Executive Director's Recommendation

Commission Meeting: September 3, 2020

PROJECT Jamie L. Whitten Federal Building Public Gathering Area Security Plan Modification 1400 Independence Avenue, SW Washington, DC	NCPC FILE NUMBER 8129
SUBMITTED BY United States General Services Administration	NCPC MAP FILE NUMBER 1.41(38.40)45179
REVIEW AUTHORITY Federal Projects in the District per 40 U.S.C. § 8722(b)(1) and (d)	APPLICANT'S REQUEST Approval of comments on concept design
	PROPOSED ACTION Approve comments on concept design
	ACTION ITEM TYPE Staff Presentation

USDA Jamie L. Whitten Federal Building Public Gathering Area Security Plan Modification

Proposed Perimeter Security Modification

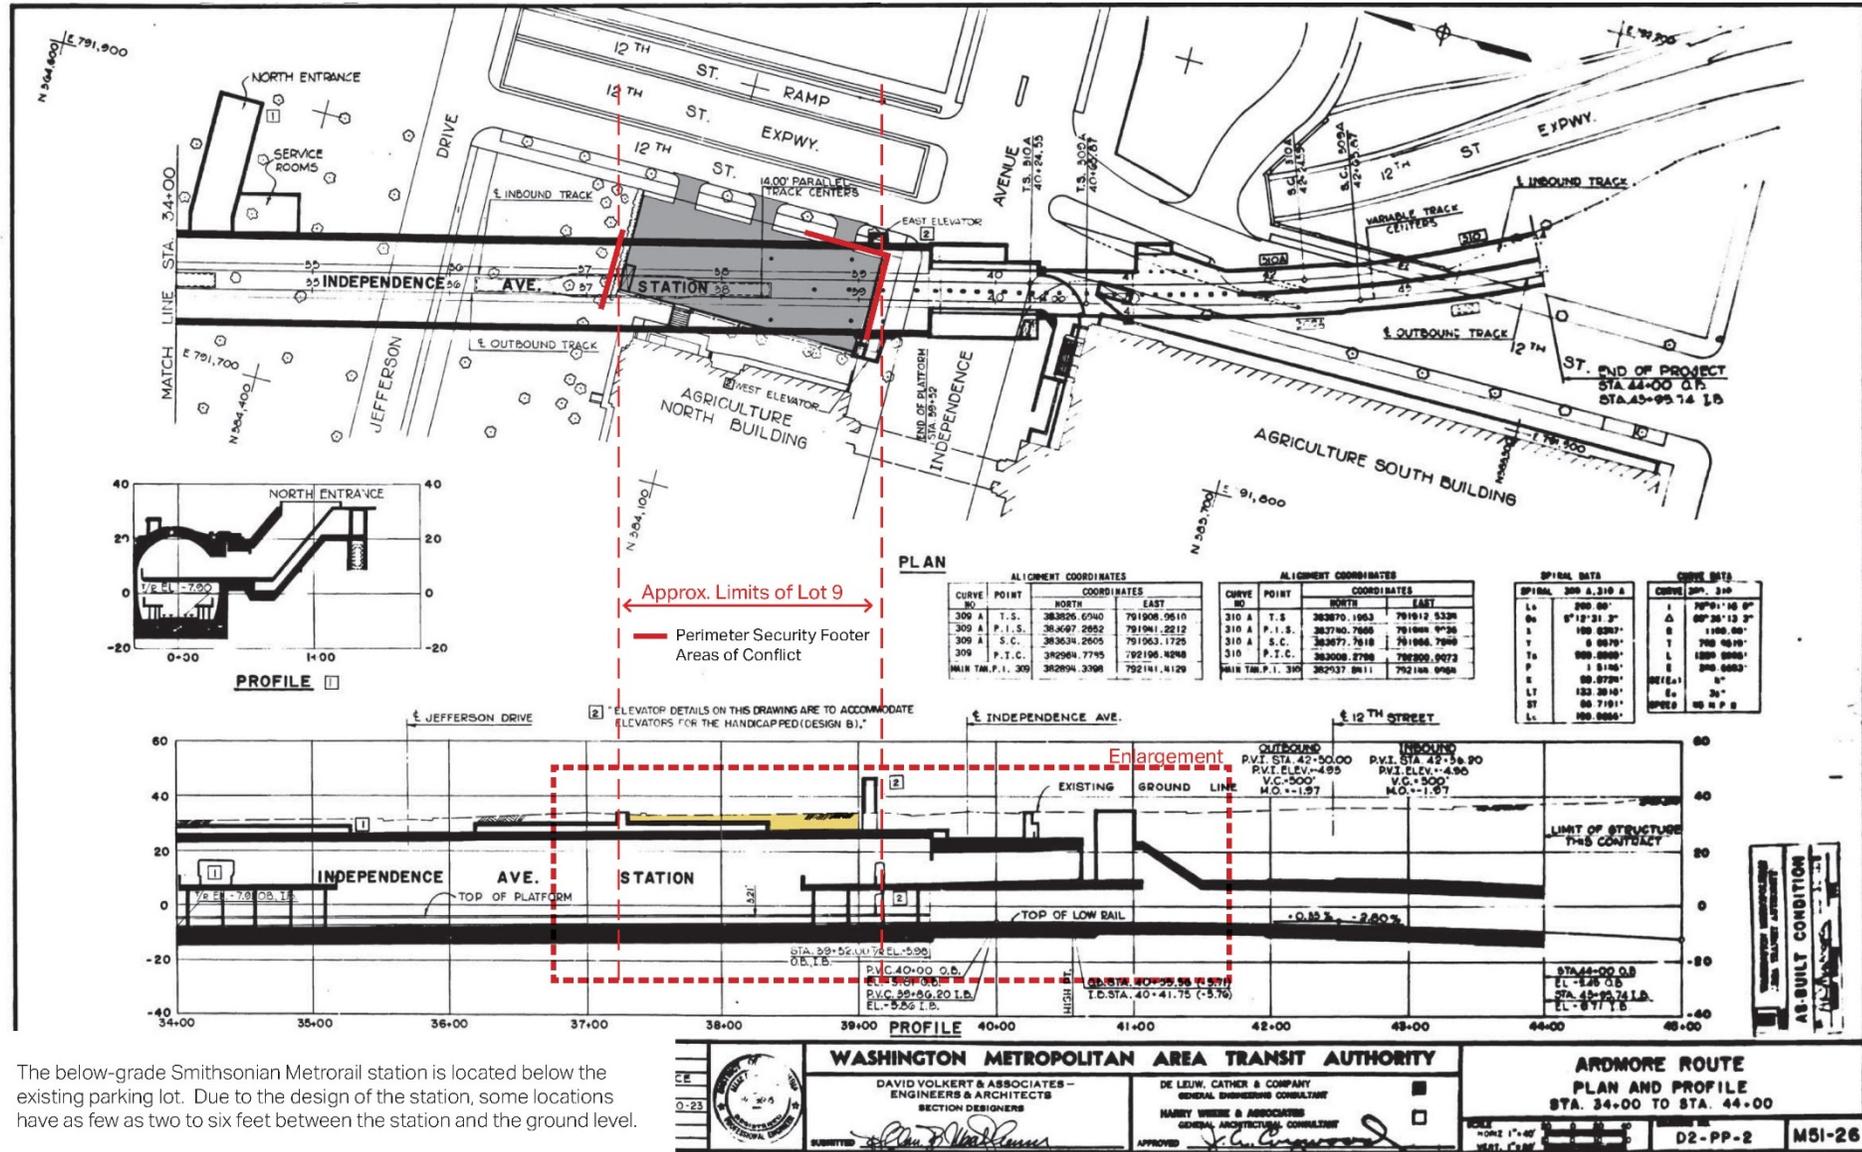
Requests the applicant evaluate whether alternative perimeter security approaches are viable along the north side of the parking area, given the character of the adjacent NPS gardens and the distance from the street.

Requests the applicant coordinate with NPS regarding the north line of the perimeter security to avoid impacts to areas under NPS jurisdiction.

The open space along the north side of the property is maintained by the National Park Service. Currently, the area is programmed with a garden. Given the proximity of the proposed security elements to NPS lands, staff recommends the **Commission request the applicant coordinate with the National Park Service regarding the north line of the perimeter security to avoid impacts to areas under NPS jurisdiction.** Further, given the different character of this area, including the planter boxes and gardens, it may be helpful to consider whether different security measures might be appropriate, including benches or other landscape features. The north perimeter is also much further from the street compared to the other sides. As such, staff recommends the **Commission request the applicant evaluate whether alternative perimeter security approaches are viable along the north side of the parking area, given the character of the adjacent NPS gardens and the distance from the street.**

Site Section – Metro Station

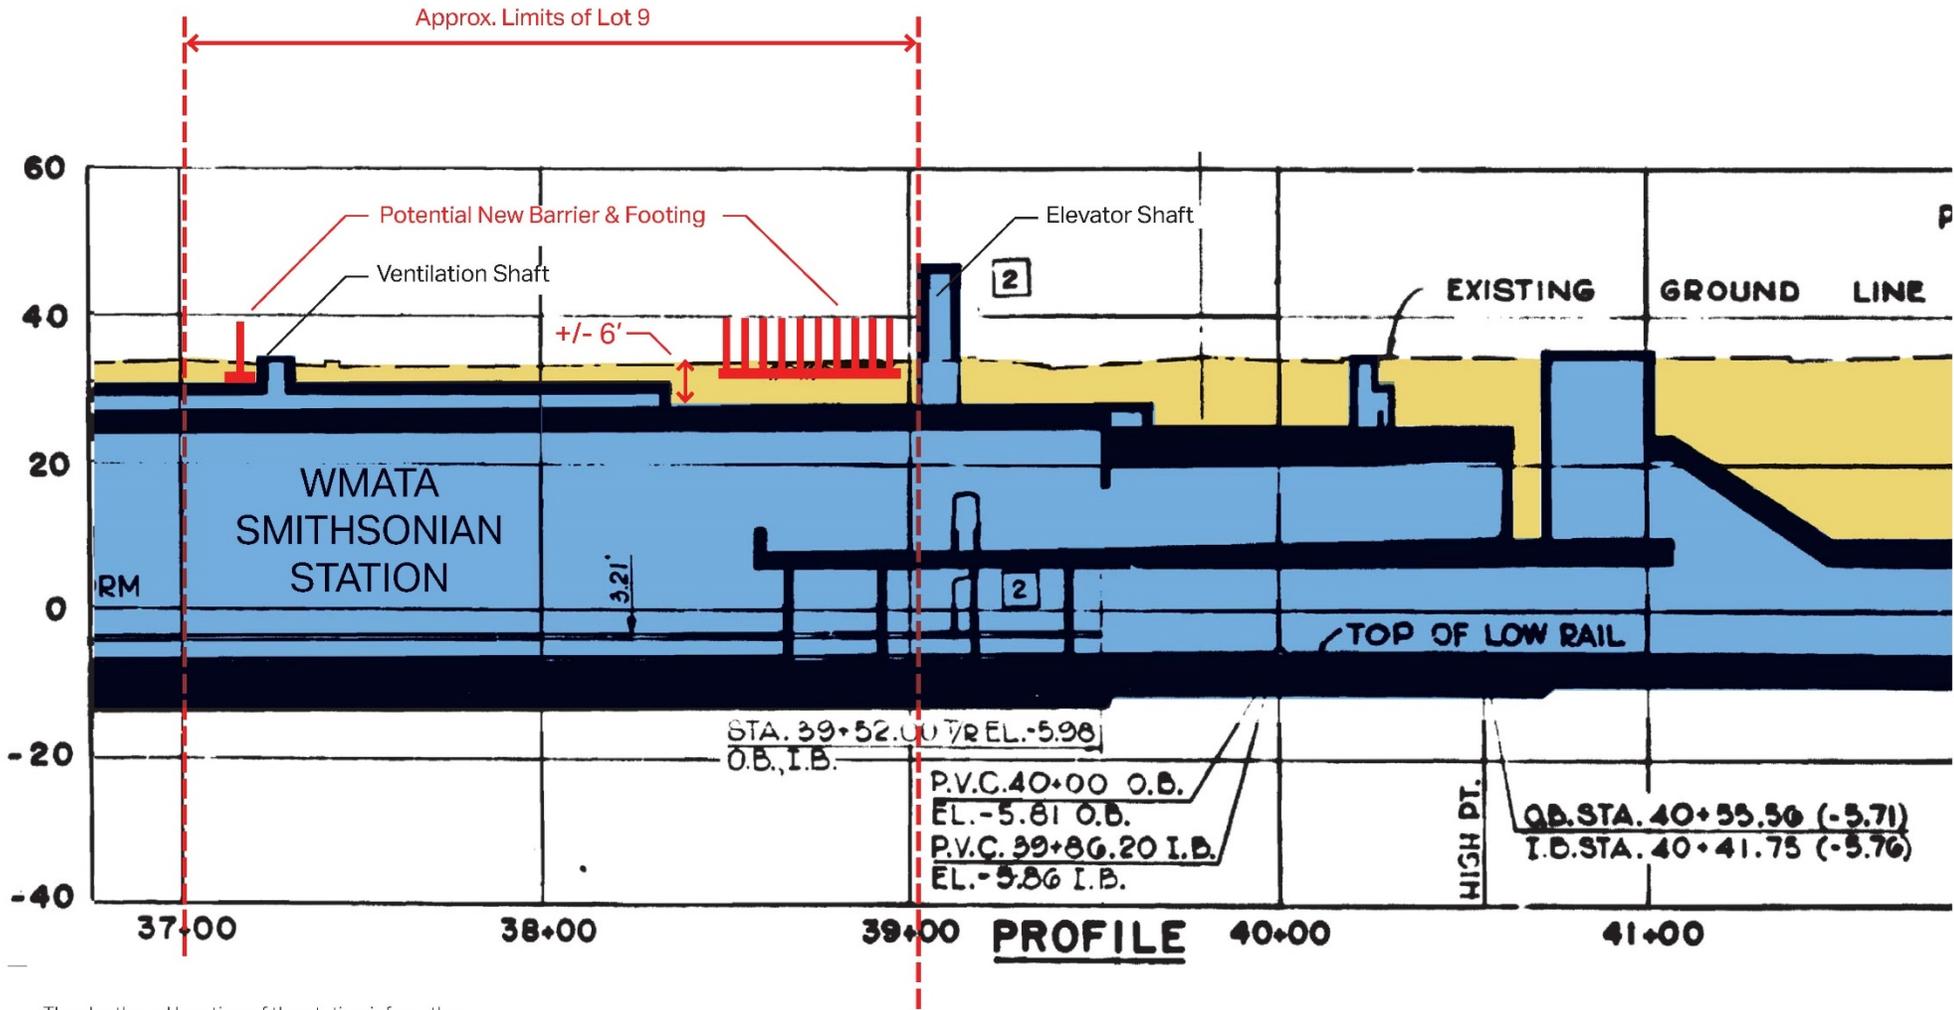
Requests the applicant provide at the next review a detailed landscape plan and palette and confirmation that any trees or plantings shown above or near the below-grade WMATA station will be viable given the shallow soil conditions.

Requests the applicant coordinate with WMATA to ensure that the proposed improvements do not create conflicts with the underground station and tunnel.
